Client:
JANE DAVIES

Project:
ALLEYNE WAY ELMER

Drawing Title:
PROPOSED FLOOR PLANS AND ELEVATIONS

PROPOSED EAST ELEVATION

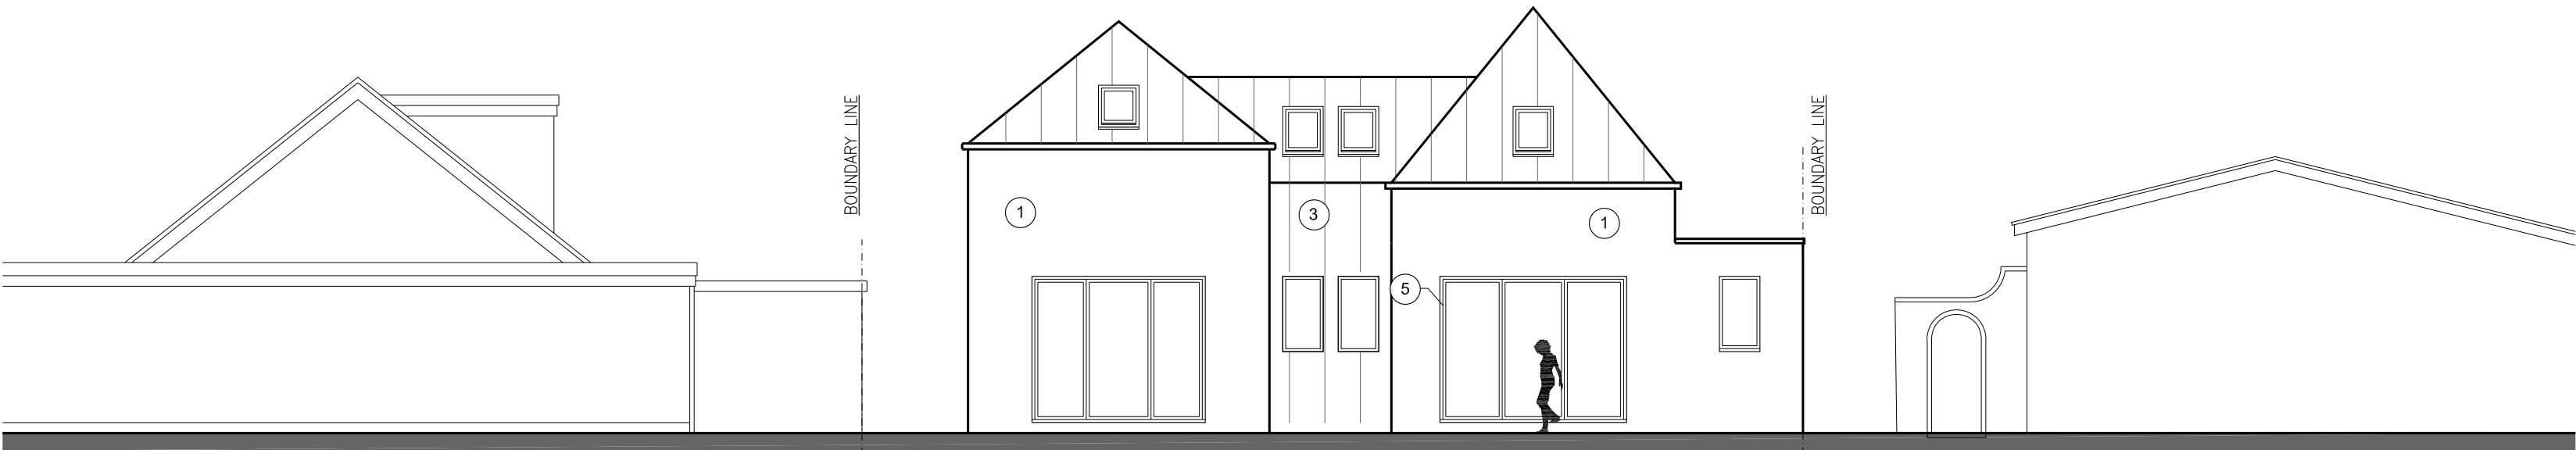
REV A 18.06.18 - EAST ELEVATIONS REVISED TO SUIT PLANNING OFFICERS COMMENTS
